Subject: Product Change Notification

RMDX60-\_\_\_\_\_ Series  
RCDX60-\_\_\_\_\_ Series

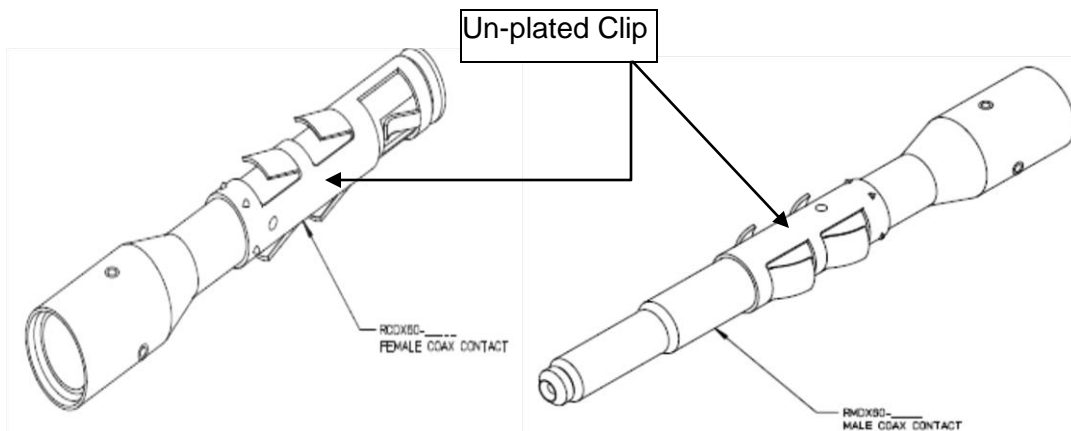
Plating will be eliminated from the retention clip of the contact.

The change eliminates a non-value add operation.

There is no impact on the final fit and function of the part in usage. The form will be changing slightly and will be observed in the contact clip coloration. The change has no impact on the performance of the part. This component serves no electrical function and therefore will not impact electrical performance. The mechanical structure of the component is determined by base material and therefore it will maintain existing retention features.

Implementation will be phased in as existing inventories are exhausted in the distribution and inventory pipeline. All product will be shipping in new format on July 1<sup>st</sup> 2012.
